Finance Contract:	SERBIAN INLAND WATERWAY INFRASTRUCTURE Finance Contract between the Republic of Serbia and European Investment Bank (Official Gazette of the Republic of Serbia - International Contracts No. 02/2019)
Procurement procedure:	Works on reconstruction and expansion of the Bogojevo Port in Serbia
MCTI reference:	EIB-GtP/342-01-005400/2022-06/1
Type of document:	Clarification No 6 to Tender Dossier
Number of pages:	8
Number of attachments:	-
Date:	February 24, 2026

Clarification No. 6 to TD

Clarification of Volume 3, Part I – General Information, Volume 4, BoQ, Vol. 5, Design documents and drawings

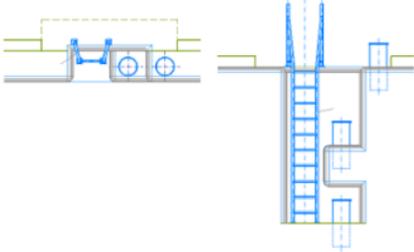
<p>Question 13</p> <p>Please, provide us with technical specifications with grain size distribution curves for materials according to column “Item from BoQ” from the table below:</p>	<p>Answer 13</p> <p>The design defines the filling of the port plateau with dredged material from the Danube. In granulometric terms, this material consists of sand to sandy gravel of various fractions. Stabilization and compaction to the required density will be carried out in full accordance with the Geotechnical Report, which forms</p>

No	Specification	Item from BoQ
Sandy gravel		
1	Sandy gravel, Ms=20Mpa	Items: 8.1.4.; 9.1.3.
	Sandy gravel, Ms=35Mpa	Items: 8.1.5., 9.1.4.
	Sandy gravel	Items: 30.5.2.
	Sandy gravel	Items: 28.2.6.
Gravel sandy		
2	Gravel sandy	Items: 28.2.8
	Gravel sandy Ev2=65 MN/m ² , Ev2/Ev1<2.5.	Pos: 20.2.4; 21.2.3.; 22.2.3; 23.2.3.;25.2.3;26.2.3; 27.2.3
